Access Compliance Report

Public Rights-of-Way

(Curb Ramps)

Intersection ID: 21320	Main Street: FREDERICK_PL	Cross Street: PARK_RD	Location:	NE
ADA ID: D24DD6F4FE83	Ramp Type: PerpDiag	Initial Pass/Fail: Fail	Overall Compliance: No	Severity Score: 10
Codes/Mitigation Info/Possible Solution		Field Measurements/Component Compliance

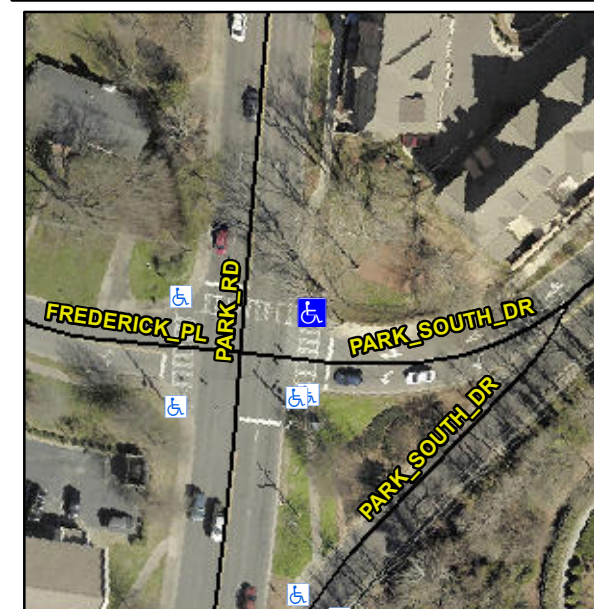
Not Found, R304.5.1, R304.5.3

Compliance	Description	Data	Compliance	Description	Data
N/A	Ramp Length (in)	58.0	Yes	Ramp Slope (%)	7.7
No	Ramp Width (in)	36.0	No	Ramp XSlope (%)	2.5
N/A	Flare Type LT	N/A	N/A	Flare Type RT	N/A
N/A	Flare Slope LT (%)	N/A	N/A	Flare Slope RT (%)	N/A
N/A	Flare Traversable LT?	N/A	N/A	Flare Traversable RT?	N/A
N/A	Landing Length (in)	N/A	N/A	DWS Provided?	N/A
N/A	Landing Width (in)	N/A	N/A	DWS Contrast?	N/A
N/A	Landing Slope (%)	N/A	N/A	DWS Length (in)	N/A
N/A	Landing X Slope (%)	N/A	N/A	DWS Full Width?	N/A
N/A	Landing Curb? (Y/N)	N/A	N/A	DWS Offset (in)	N/A
N/A	Shared Landing?	N/A			
N/A	Gutter Ponding?	N/A	N/A	Gutter Slope (%)	N/A
N/A	Gutter Lip Ht (in)	N/A	N/A	Gutter X Slope (%)	N/A
N/A	Painted X Walk1?	Yes	N/A	Painted X Walk2?	Yes
	X Walk 1 Direction	To NW		X Walk 2 Direction	To SW
N/A	X Walk 1 Width (in)	110.0	N/A	X Walk 2 Width (in)	110.0
	X Walk 1 Slope (%)	2.3		X Walk 2 Slope (%)	1.2
	X Walk 1 X Slope (%)	3.4		X Walk 2 X Slope (%)	1.1

Remove & Replace Curb Ramp With Two New Directional Ramps or Equivalent.
